**TOWN OF NEWBURGH
PLANNING BOARD
TECHNICAL REVIEW COMMENTS**

PROJECT: 11 OLD BALMVILLE ROAD
PROJECT NO.: 2018-18
PROJECT LOCATION: SECTION 84, BLOCK 5, LOT 26
REVIEW DATE: 31 JANUARY 2019
MEETING DATE: 7 FEBRUARY 2019
PROJECT REPRESENTATIVE: PITINGARO & DOETSCH

Subject: 11 Old Balmville Road

LANDSCAPING PLAN
FOR
11 OLD BALMVILLE ROAD
TOWN OF NEWBURGH, ORANGE COUNTY, NY

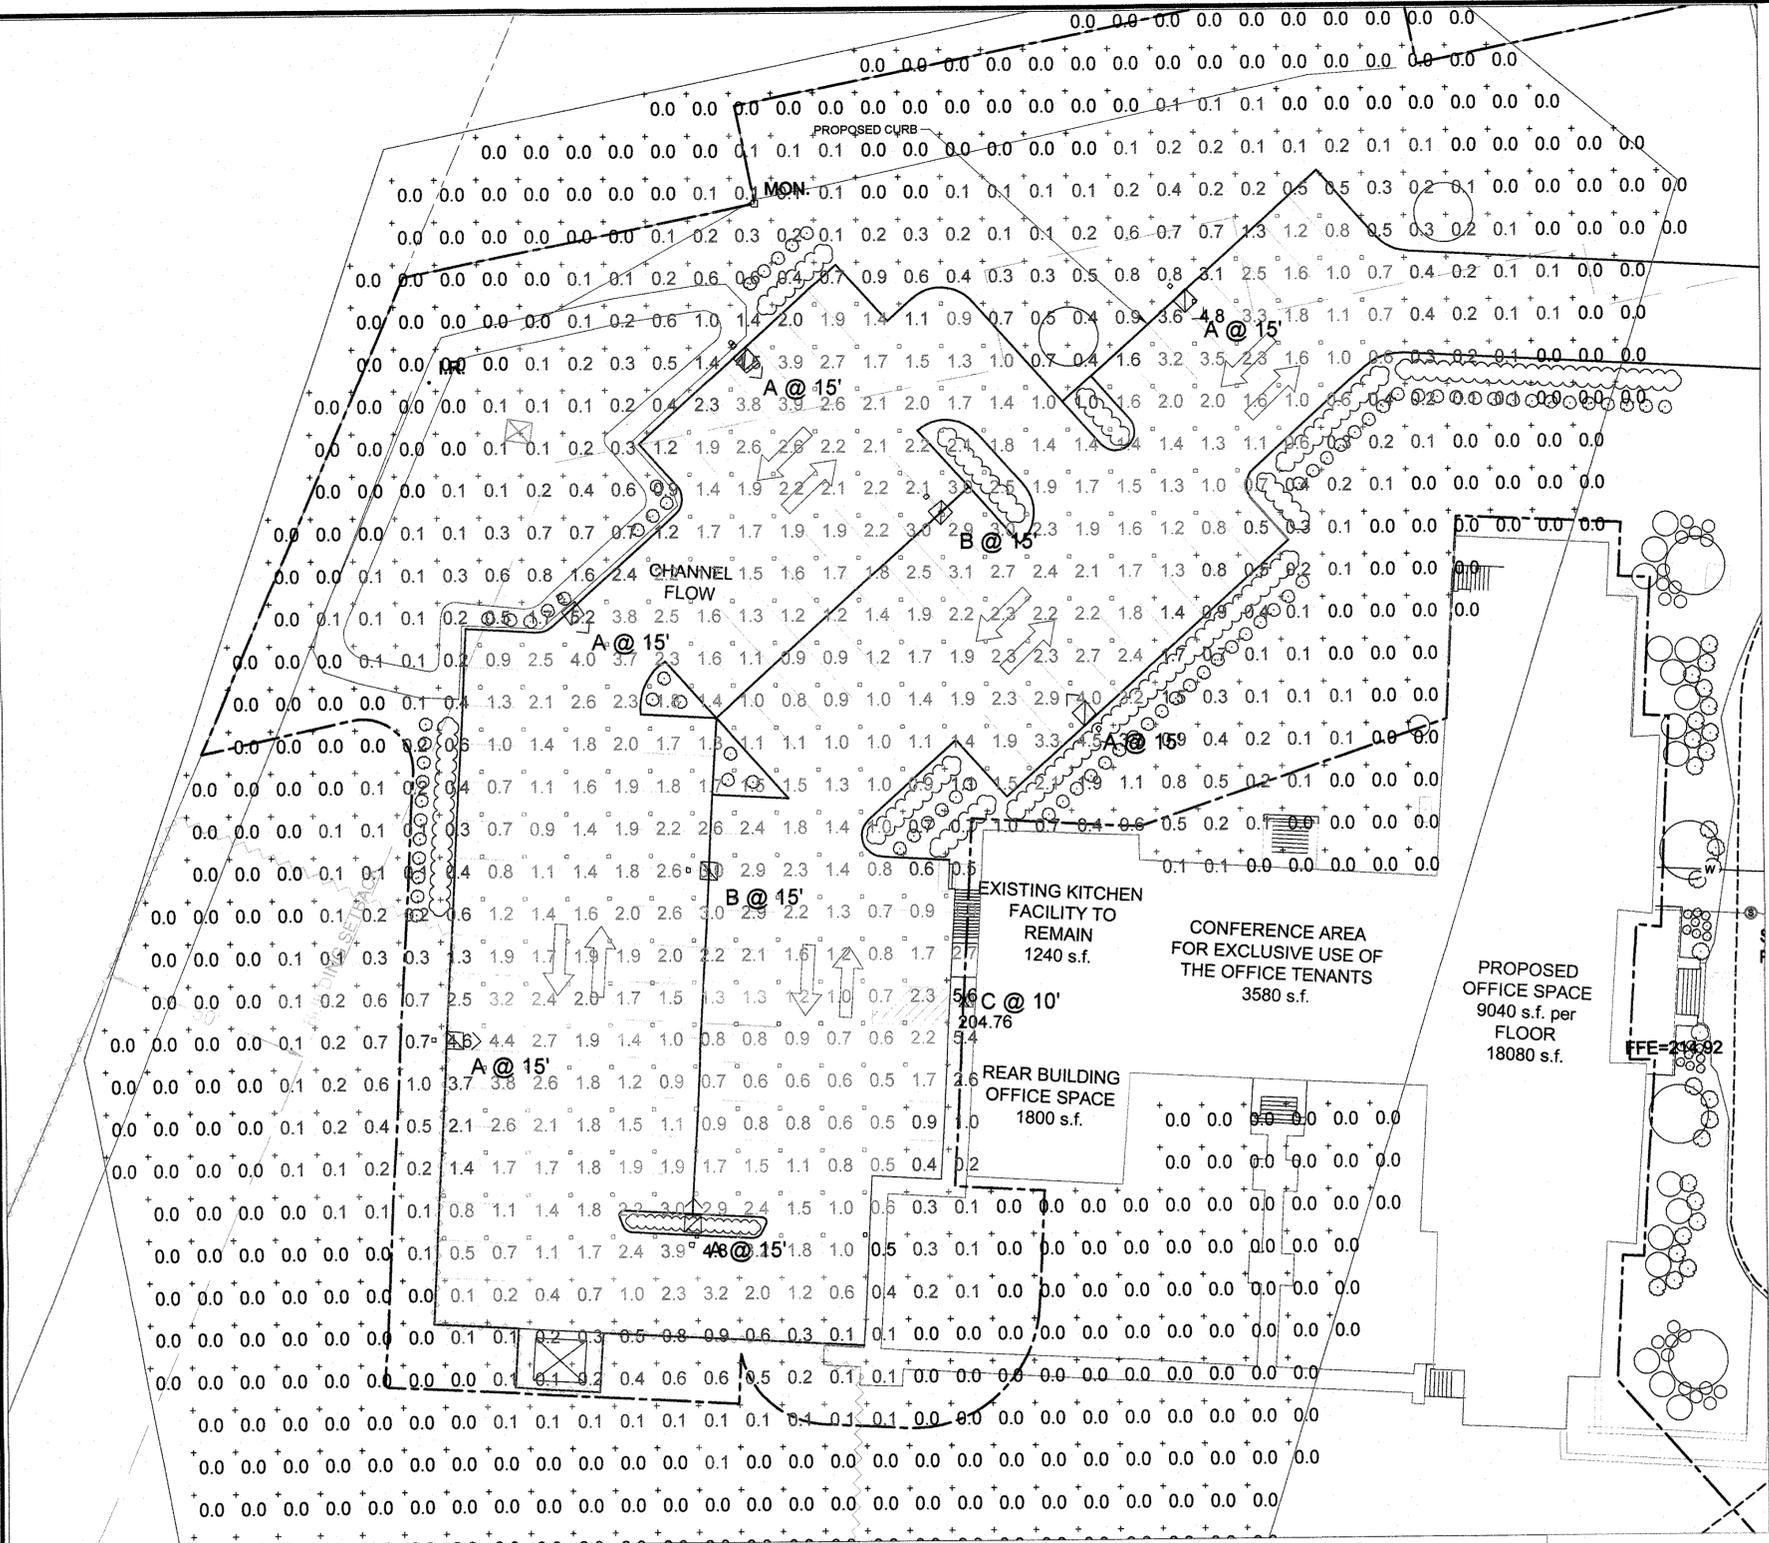
1. The plans now include the addition of four (4) specimen trees along the entrance and exit of the drive within the areas scheduled for disturbance to augment those specimen trees which exist.

2. The proposed boxwood hedge specified has been revised to Green Velvet, Buxus Sempervirens as suggested.
3. The proposed lavender specified has been revised to Catnip, Nepeta Faassenii, Pursian Blue as suggested.

7. The large tree to the south of the building is now indicated as to be removed.

-
8. The proposed Kwanzan Cherry trees specified have been replaced by Aurora Dogwood as suggested. Kwanzan Cherry trees were included in the more open area adjacent to the parking area.

9. The proposed pear trees specified have been replaced by Gold Rain flowering trees. They have been moved slightly away from the building to allow larger growth without impact to the building.

OUTLET CONTROL STRUCTURE - TYPE 1
FOR STORMWATER MANAGEMENT POND
NOT TO SCALE

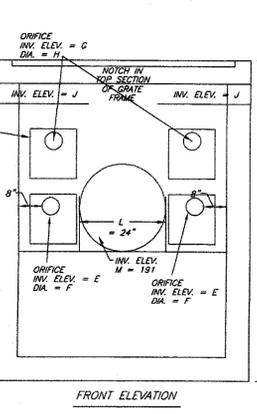
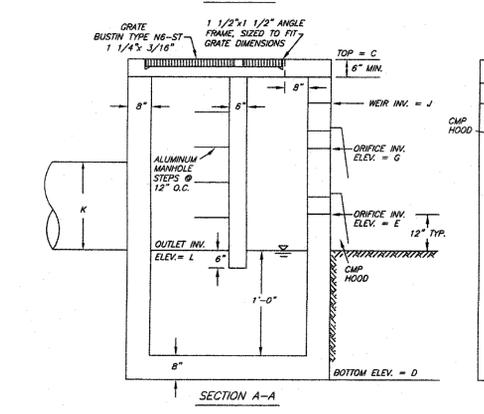
1. Response comment #15 is incomplete. A review of the revised Stormwater Management plan and report continue to identify an invert for the stormwater detention facility below existing grades. The lowest topographic elevation on the site is 192 while the discharge is identified as 190 in the stormwater management report. Future submissions should label the invert on the plans.
2. Bioretention area detail continues to be located on the plan.
3. Existing site water and sewer utilities will continue to remain as they are in the current state with no changes to the utility services.
4. The Applicant's representative requested to evaluate the fence detail for the detention pond. Detail identifies a 6 ft. fence with 3 strands of barbwire on top. Typical detention pond fencing is 4 ft. black vinyl coated chain linked fence.

14. The pre-development soils mapping is now correctly identified as Soil Group C.
 15. The discharge of the stormwater basin has been modified and is not at elevation...
